Town of Vienna
Board of Architectural Review
Revision Approved with Conditions
June 17, 2021

LOT 29
ELEV. 1
SCHEME #3B

DIMENSIONAL AND ADDRESS PLAN
 VIENNA MARKET
 SITE PLAN
 TOWN OF VIENNA, VIRGINIA
 MAPLE AVENUE CORRIDOR DISTRICT

1. CHURCH STREET - PROPOSED

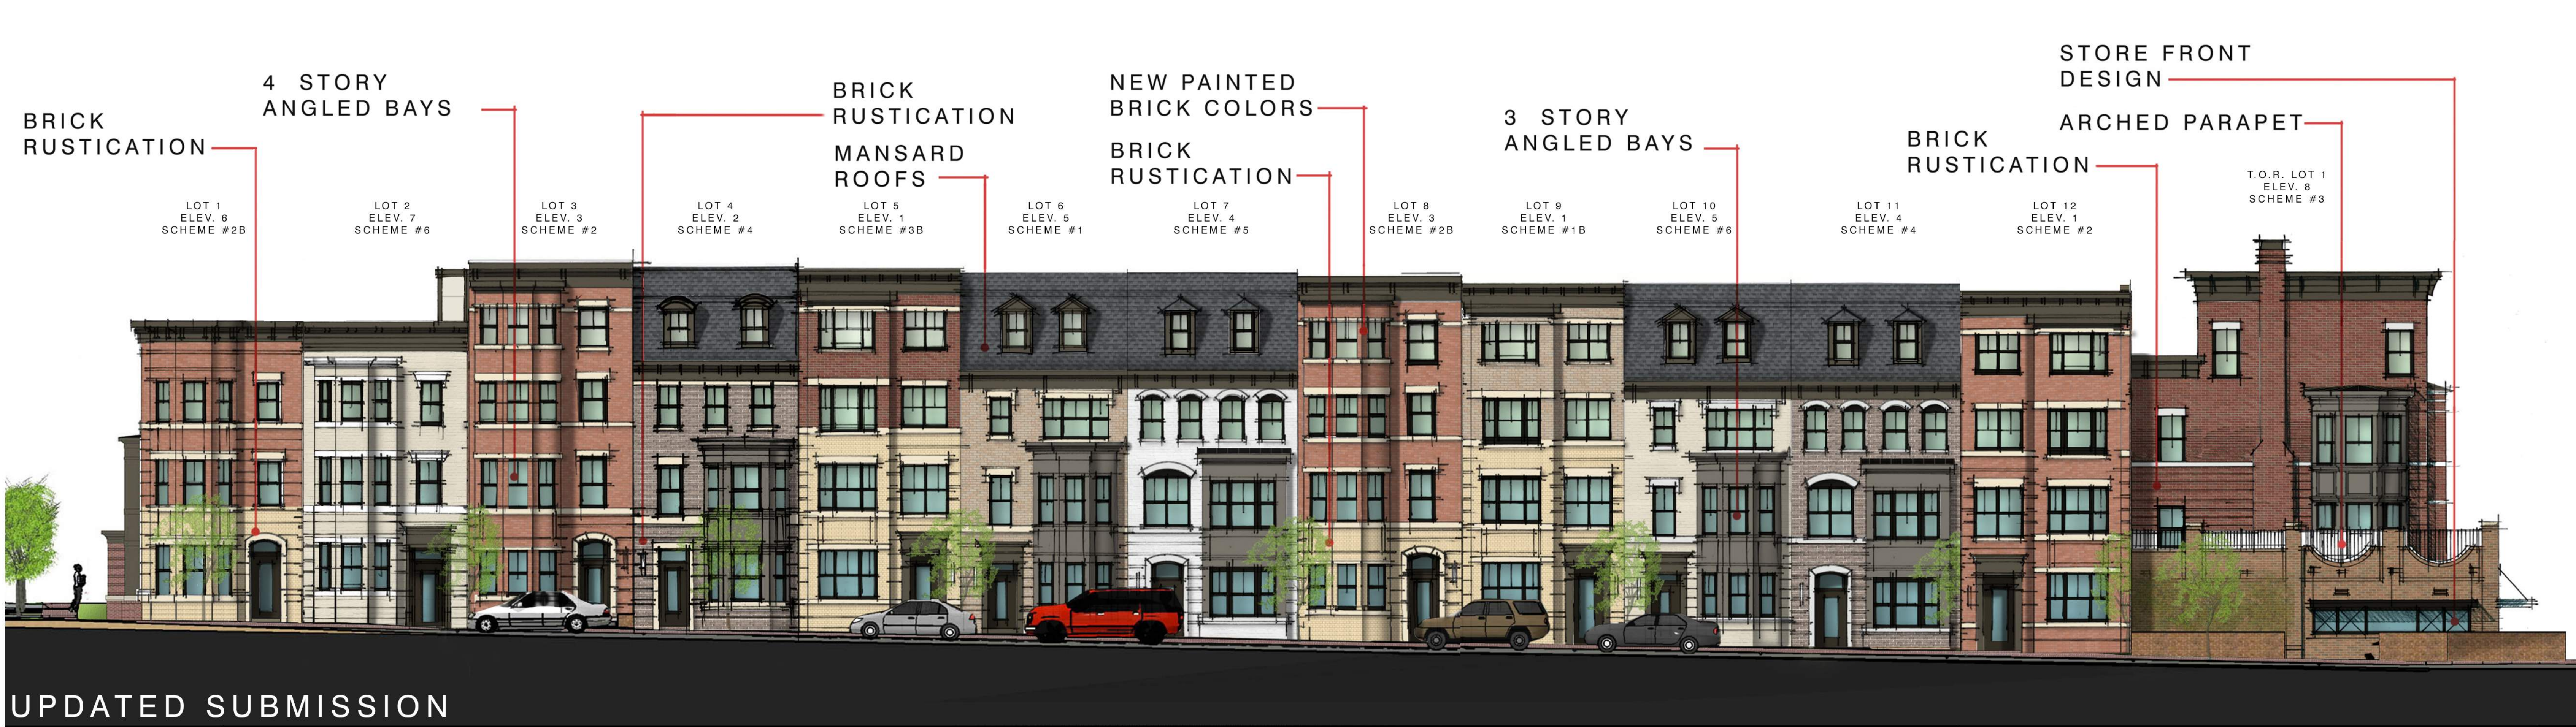
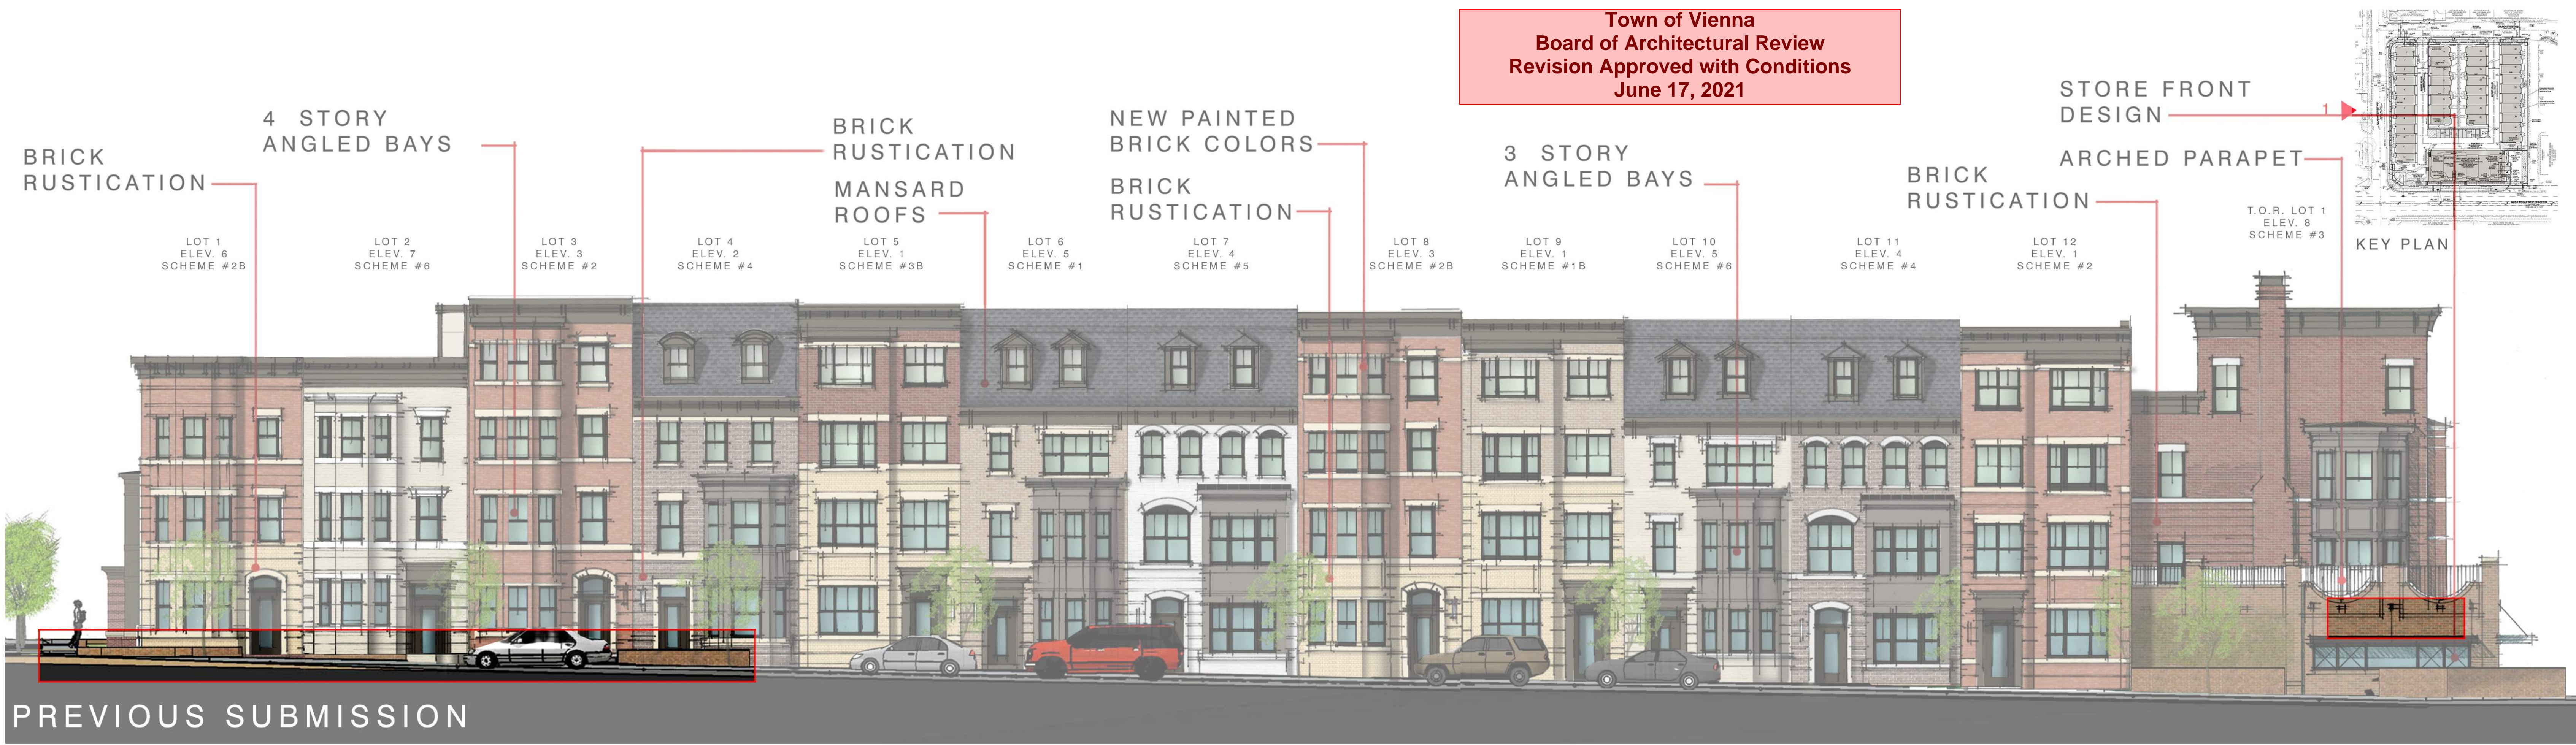
SIDE TERRACE
NEW WINDOWS
UTILITY ROOM ENHANCEMENT
BRICK RUSTICATION

SIDE TERRACE
NEW WINDOWS
UTILITY ROOM ENHANCEMENT
BRICK RUSTICATION

TOWNS OVER RETAIL

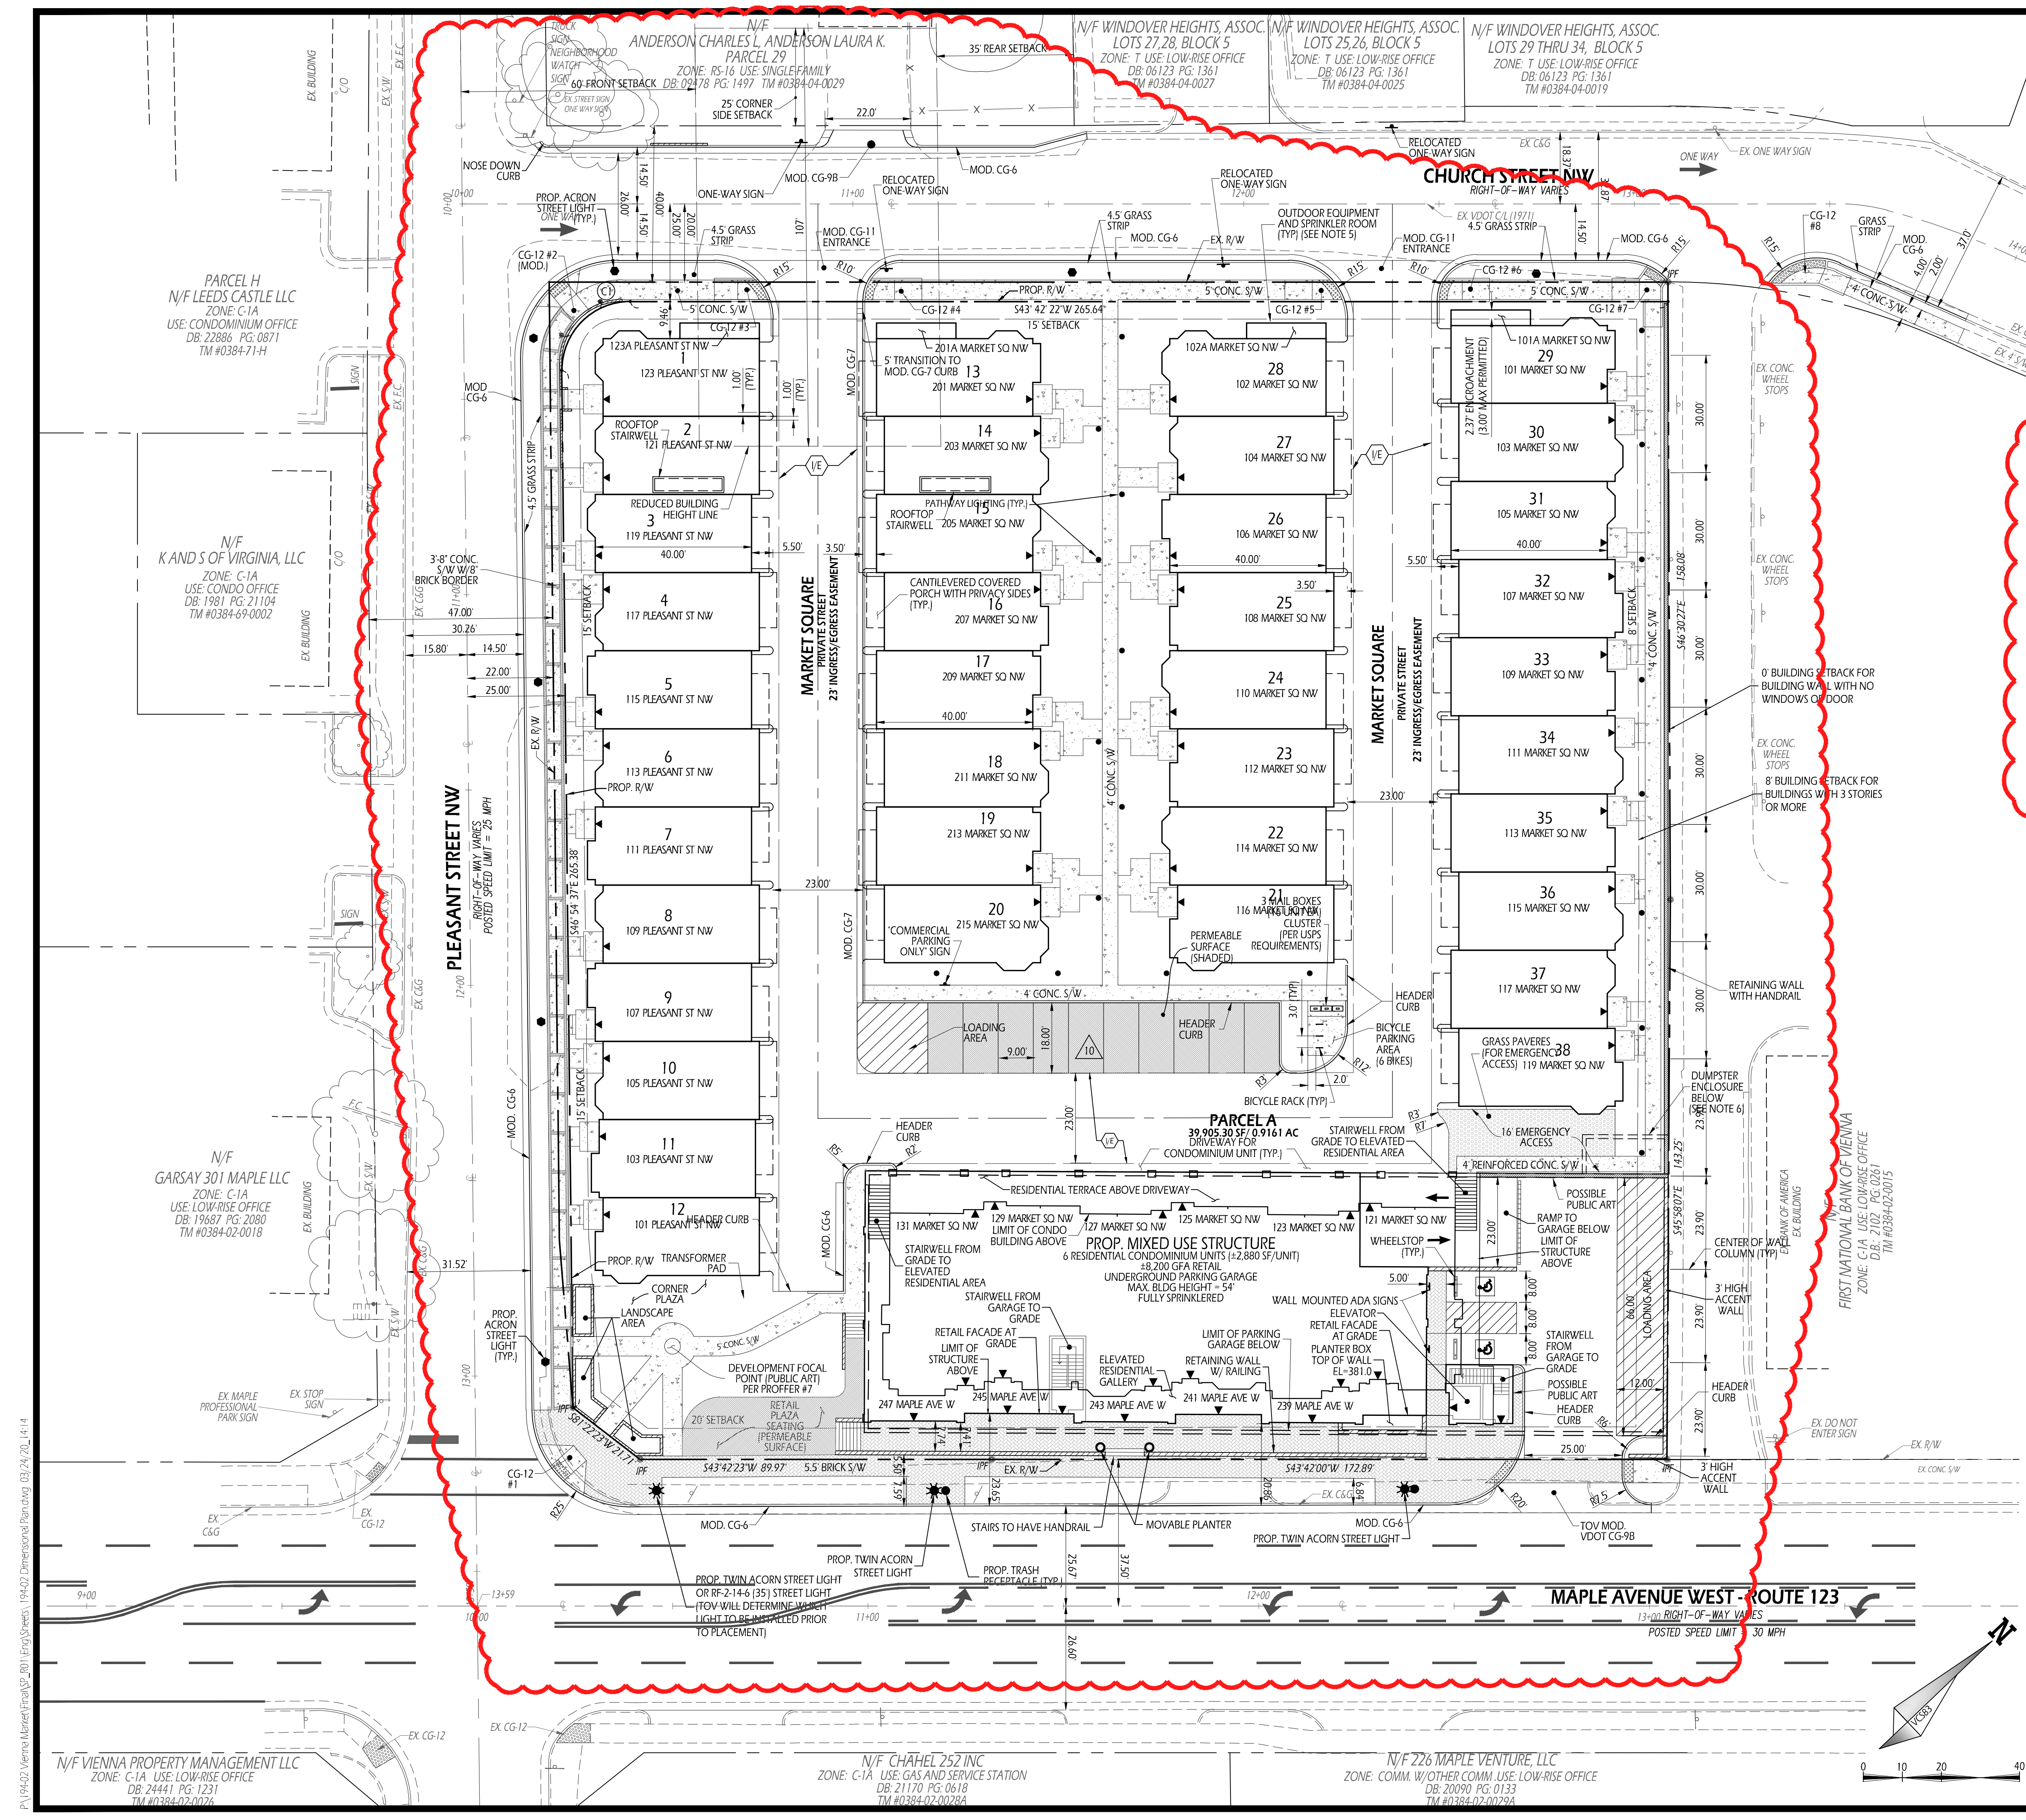
Staff note: Additional material change.
